CITY OF COCONUT CREEK
DEVELOPMENT REVIEW COMMITTEE (DRC) REVIEW #4
11-18-19

PROJECT NAME:	7-Eleven #34941		
PROJECT NUMBER:	19020004		
LOCATION:	SE Corner of Coconut Creek Parkway and Banks Road		
APPLICANT/AGENT:	Keith & Associates		
REVIEW/APPLICATION	Site Plan		
DISCIPLINE	REVIEWER	EMAIL	TELEPHONE
DRC Chair	Liz Aguiar – Principal Planner	laguiar@coconutcreek.net	(954) 973-6756
Planning	Linda Whitman – Senior Planner	lwhitman@coconutcreek.net	(954) 973-6756
Planning	Natacha Josiah – Planner	njiosiah@coconutcreek.net	(954) 973-6756
Planning	Michael Righetti – Senior Project Manager	mrighetti@coconutcreek.net	(954)-973-6756
Building	Sean Flanagan – Deputy Building Official	sflanagan@coconutcreek.net	(954) 973-6750
Engineering	Eileen Cabrera - Engineer II	ecabrera@coconutcreek.net	(954) 973-6786
Engineering	Mohammed Albassam- Engineer I	malbassam@coconutcreek.net	(954) 973-6786
Fire	Jeff Gary – Fire Marshal	jgary@coconutcreek.net	(954) 973-1563
Landscape	Scott Peavler - Landscape (consultant)	speavler@craventhompson.com	(954) 739-6400

PROJECT NAME:	7-Eleven #34941
PROJECT NUMBER:	19020004
LOCATION:	SE Corner of Coconut Creek Parkway and Banks Road
APPLICANT/AGENT:	Keith & Associat

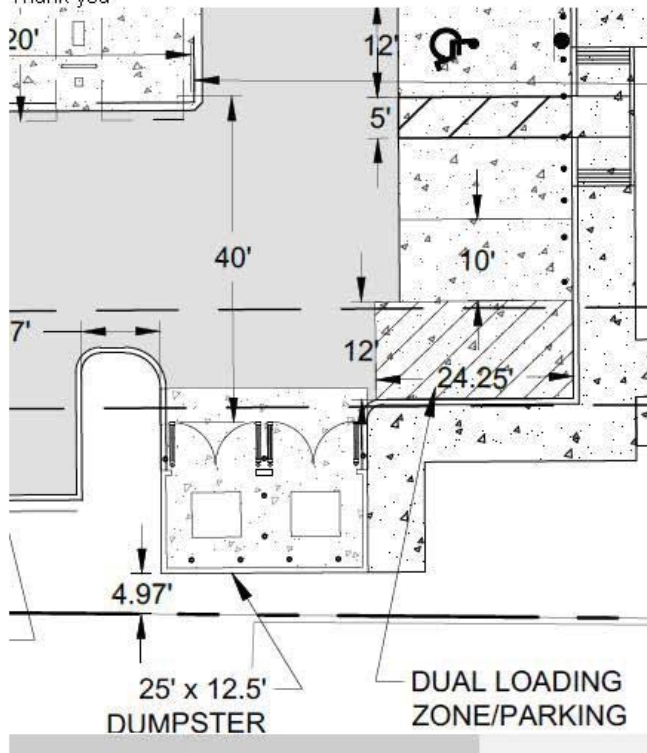
Hello Ashley
The attached site plan now includes a call-out of where the 40' truck could stop to lift the dumpster. Below is a screen shot of the section in question. Please let me know if this is approvable.
Thank you
